MINUTES  
PLANNING COMMISSION  
CITY OF LAKEWOOD  
12650 DETROIT AVENUE  
AUDITORIUM  
JULY 8, 2025  
6:00 P.M.  
RECORDED

4. Docket No. 07-25-25  
16024 Madison Ave.  
Neighborhood Pediatrics LLC

Michael Daso, Daso Properties, applicant requests the review and approval of a parking lot – pursuant to Chapter 1143.09, Parking Plan Review and 1143.10, Exceptions for Required Minimums. Property is in the C2 - Commercial, General Retail district. (Page 2)

**AS1.0**  
SHEET NO.

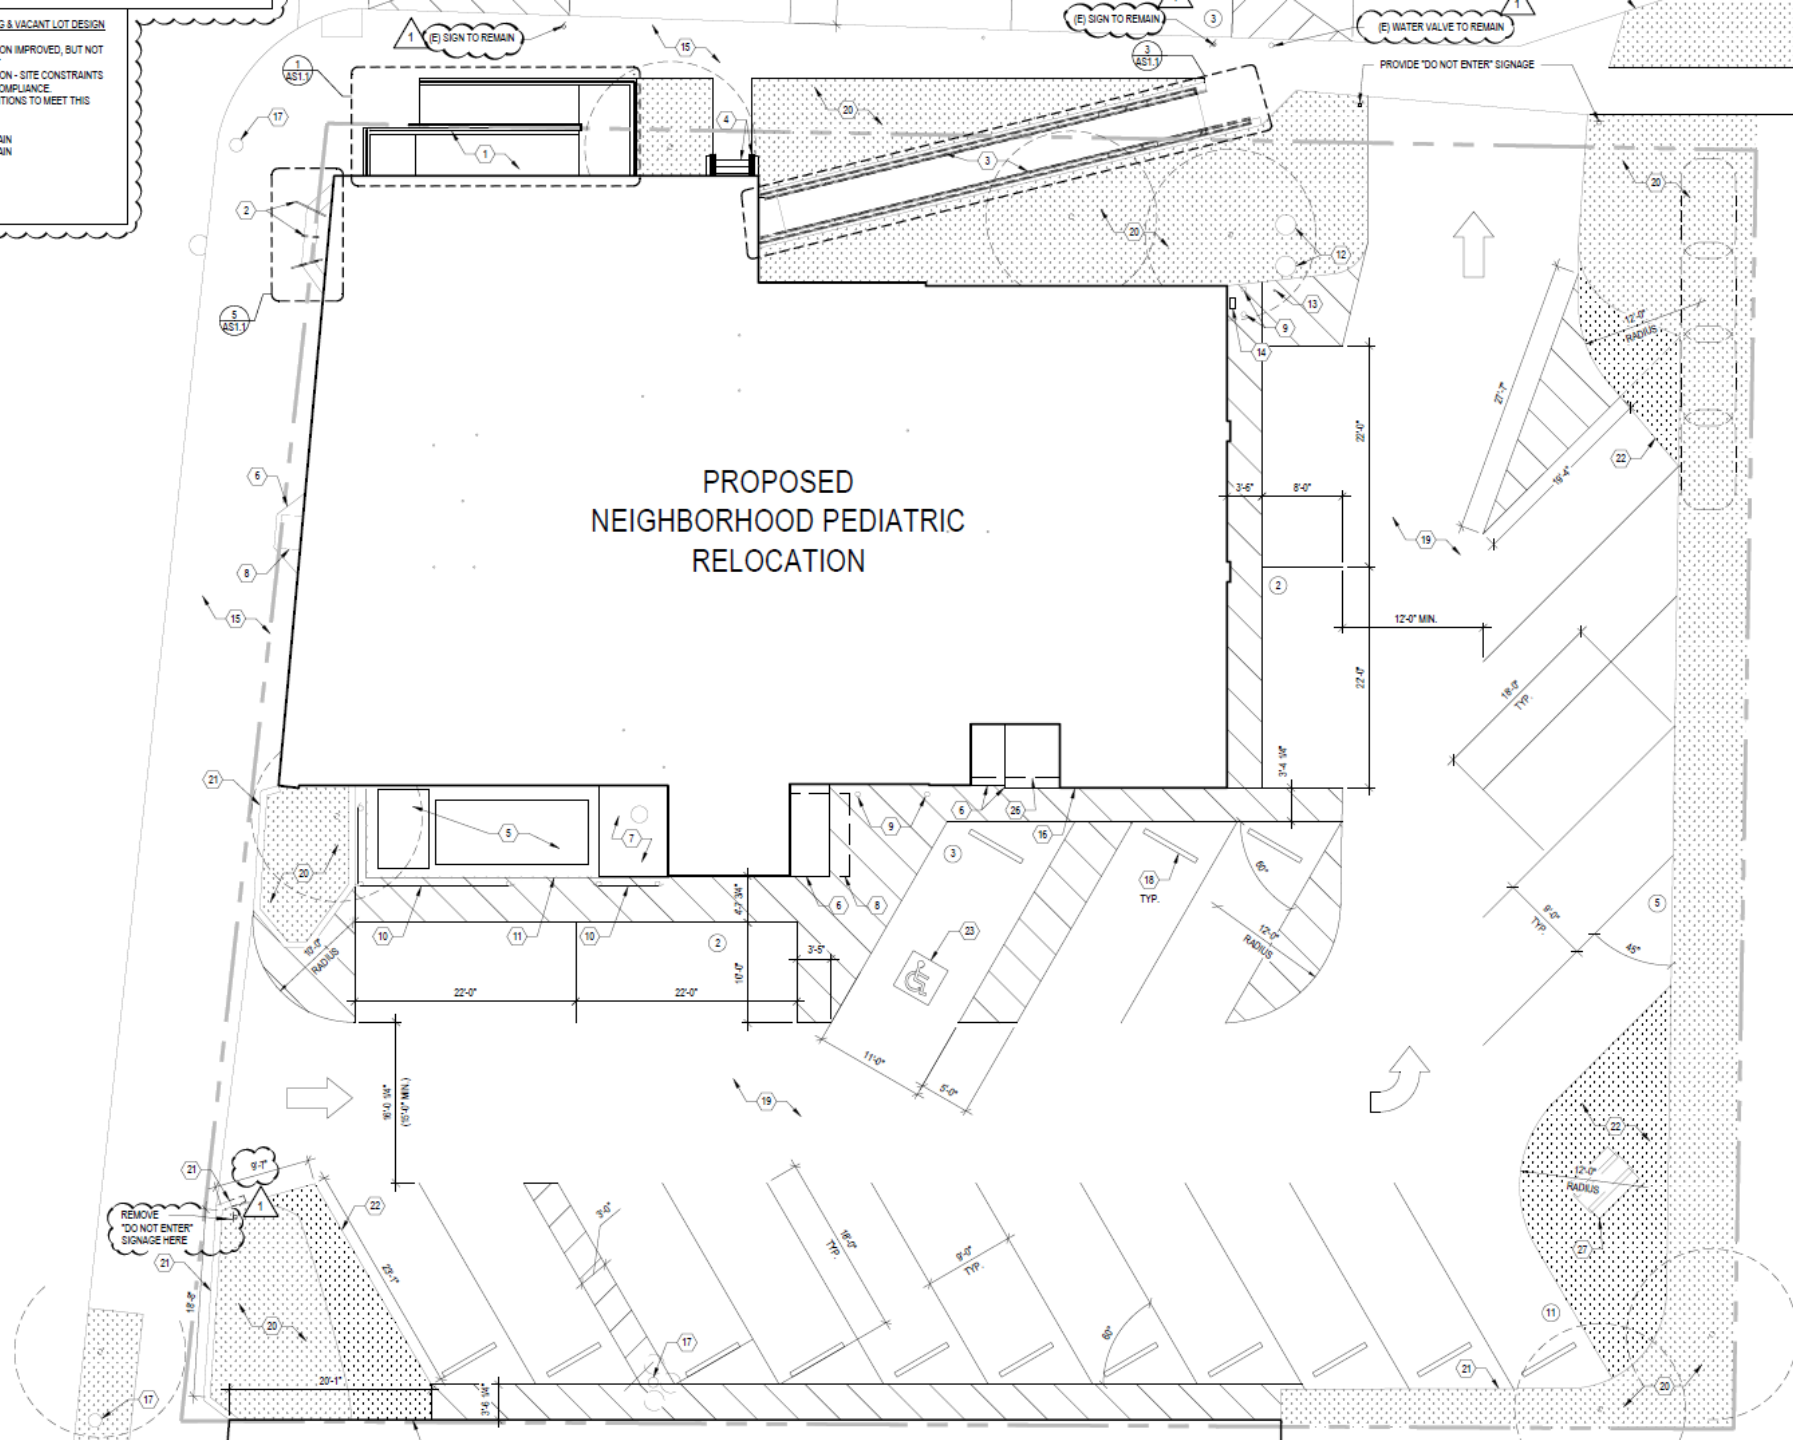
There are five to eight patient units per appointment slot. Approximately 40% of the patients are Lakewood residents and walk to the appointments.
- Dimensions are not shown on the drawing for the Northland Avenue curb cut. The Madison Avenue curb cut dimensions are 16 feet wide.
  - Mr. Papke stated that the applicant should not do work on the Northland curb cut and apron as the city was slated to do work on Northland Avenue through the spring of 2026.

- The applicant coordinates with the City of Lakewood Engineer to coordinate exterior/parking lot improvement work with the pending Northland Avenue water/street project – including maintenance of the existing site curb cut to Northland (16 foot width dimension).
